REVISED RESPONSE TO REQUEST FOR ADDITIONAL INFORMATION

APR1400 Design Certification

Docket No. 52-046

RAI No.: 481-8546

Figure 1 RCS Elevation View

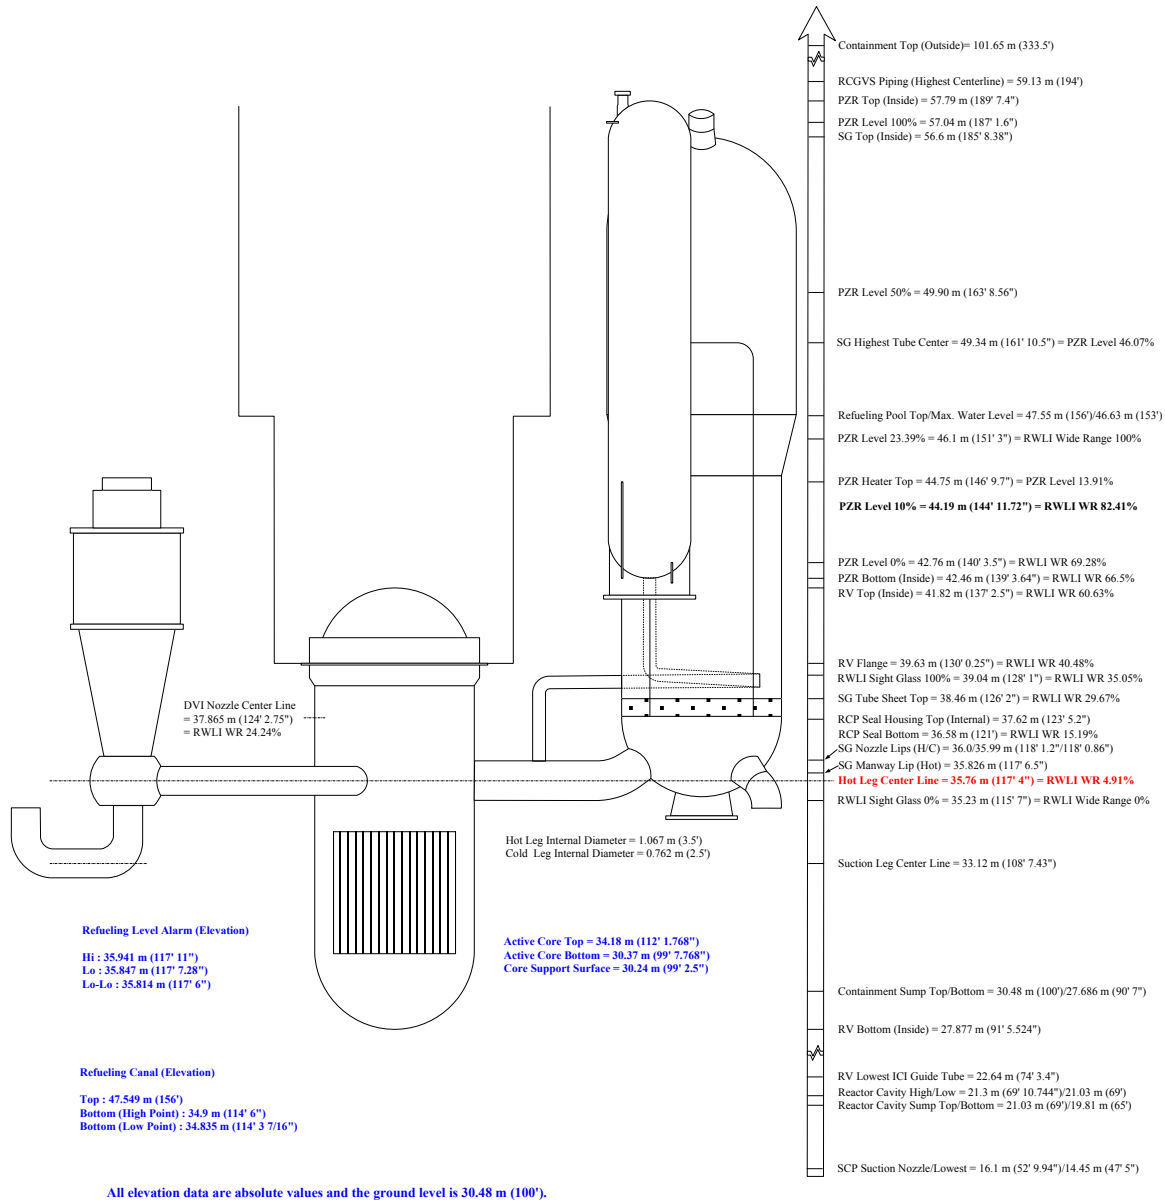
- 2.K A description on an entry condition into the loops filled or the loops not filled will be added in Applicability sections of B3.4.7 and B3.4.8 as follows;

In the MODE 5 with RCS loops not filled condition, the steam generators (SGs) cannot be used for the core decay heat removal because the SG tubes contain water vapor voids or non-condensable gases that restrict the flow of reactor coolant through the SG tubes to less than the flow needed for adequate secondary heat transfer. The loops not filled condition is entered during draining of the RCS when the reactor coolant level is below 134 ft, which is about 28 ft below the highest SG tubes. Below this level, containment atmospheric pressure can no longer completely support the column of water remaining in the SG tubes above the reactor coolant level. At reactor coolant levels below 134 ft, water vapor voids begin forming in the horizontal portions of SG tubes, beginning with the highest tubes. The number of affected tubes increases as RCS level decreases until all tubes contain water vapor voids. SG tubes containing voids of water vapor, at the saturation temperature corresponding to vapor pressure of the coolant in the tubes, block coolant flow and secondary heat transfer. When reactor coolant level has decreased to 119 ft 1 in (just above the highest point of the hot leg), air can begin entering the hot leg through the surge line connection and displace the coolant remaining in the SG tubes. This results in the SG tubes being filled with non-condensable gases. The condition in MODE 5 with RCS water level within the top half of the hot legs is called mid-loop operation.

Restoring the unit to the MODE 5 with RCS loops filled condition requires raising RCS level above 134 ft during a draining operation, provided no air was introduced into the SG tubes. Restoring the unit to the MODE 5 with RCS loops filled condition following

mid-loop operation requires closing the pressurizer manway, filling the pressurizer, and dynamically venting non-condensable gases from the SG tubes and reactor vessel closure head using the RCGVS and the-reactor coolant pumps.

A forced circulation by the reactor coolant pumps (RCPs) in the MODE 5 with loops not filled condition is possible when the static head of the water from pressurizer water level establishes an RCS pressure high enough to run an RCP.

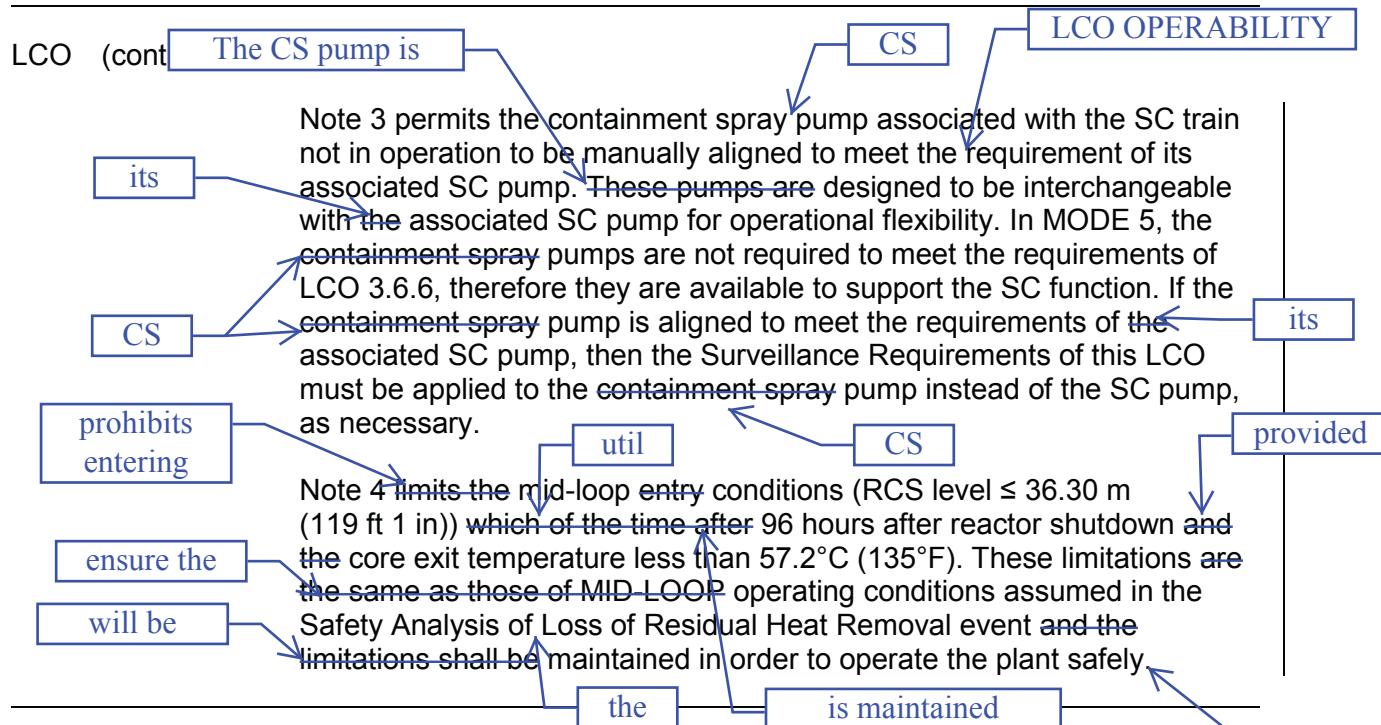
Insert the content "A" in the next sheet.

The MODE 5 with RCS loops filled condition is when the steam generators (SGs) can be used for the core decay heat removal. This loops filled condition can be maintained while draining the RCS provided the reactor coolant level is maintained above 134 ft, since below this level, containment atmospheric pressure can no longer completely support the column of water remaining in the SG tubes above the reactor coolant level. At reactor coolant level below 134 ft, water vapor voids begin forming in the horizontal portions of SG tubes, beginning with the highest tubes. The number of affected tubes increases as RCS level decreases until all tubes contain water vapor voids. SG tubes containing voids of water vapor, at the saturation temperature vapor pressure of the coolant in the tubes, block coolant flow and secondary heat transfer. When reactor coolant level has decreased to 119 ft 1 in (just above the high point of the hot leg), air can begin entering the hot leg through the surge line connection and displace the coolant remaining in the SG tubes. This results in the SG tubes being filled with non-condensable gases. The condition in MODE 5 with RCS water level within the top half of the hot legs is called mid-loop operation.

Restoring the unit to the MODE 5 with RCS loops filled condition requires raising RCS level above 134 ft during a draining operation, provided no air was introduced into the SG tubes. Restoring the unit to the MODE 5 with RCS loops filled condition following mid-loop operation requires closing the pressurizer manway, filling the pressurizer, and dynamically venting non_condensable gases from the SG tubes and RPV closure head using the RCGVS and the reactor coolant pumps.

A forced circulation by the reactor coolant pumps (RCPs) in the MODE 5 with loops not filled condition is possible when the static head of the water from pressurizer water level establishes an RCS pressure high enough to run an RCP.
